# Access Compliance Report

## Public Rights-of-Way

Intersection ID: N/A	Main Street: KIMMERLY_GLEN_LN	Cross Street: N/A	Location: S
ADA ID: BF754F392732	Ramp Type: PerpDiag	Initial Pass/Fail: Fail	Overall Compliance: No
Codes/Mitigation Info/Possible Solution		Field Measurements/Component Compliance	
Severity Score: 25

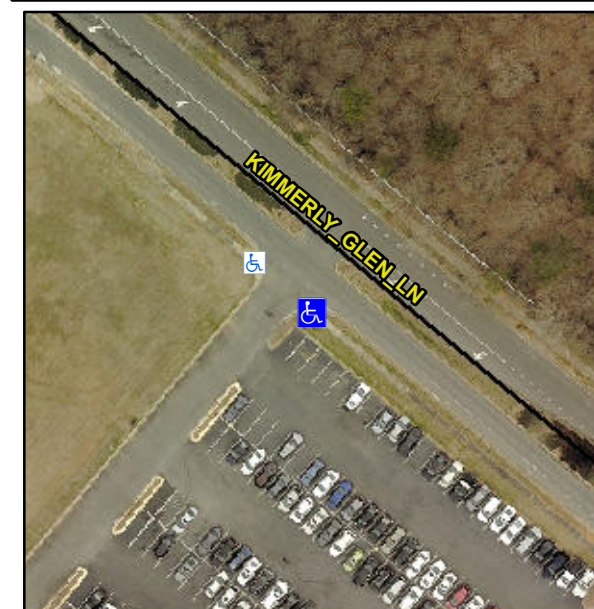
**R304.2.2, R304.5.3**

Compliance	Description	Data	Compliance	Description	Data
N/A	Ramp Length (in)	26.5	No	Ramp Slope (%)	9.5
Yes	Ramp Width (in)	51.0	No	Ramp XSlope (%)	6.0
N/A	Flare Type LT	N/A	N/A	Flare Type RT	N/A
N/A	Flare Slope LT (%)	N/A	N/A	Flare Slope RT (%)	N/A
N/A	Flare Traversable LT?	N/A	N/A	Flare Traversable RT?	N/A
N/A	Landing Length (in)	N/A	N/A	DWS Provided?	N/A
N/A	Landing Width (in)	N/A	N/A	DWS Contrast?	N/A
N/A	Landing Slope (%)	N/A	N/A	DWS Length (in)	N/A
N/A	Landing X Slope (%)	N/A	N/A	DWS Full Width?	N/A
N/A	Landing Curb? (Y/N)	N/A	N/A	DWS Offset (in)	N/A
N/A	Shared Landing?	N/A			
N/A	Gutter Ponding?	N/A	N/A	Gutter Slope (%)	N/A
N/A	Gutter Lip Ht (in)	N/A	N/A	Gutter X Slope (%)	N/A
N/A	Painted X Walk1?	No	N/A	Painted X Walk2?	No
	X Walk 1 Direction	To NE		X Walk 2 Direction	To NW
N/A	X Walk 1 Width (in)	N/A	N/A	X Walk 2 Width (in)	N/A
	X Walk 1 Slope (%)	5.6		X Walk 2 Slope (%)	7.2
	X Walk 1 X Slope (%)	4.3		X Walk 2 X Slope (%)	0.7

**Remove & Replace Curb Ramp With Two New Directional Ramps or Equivalent.**
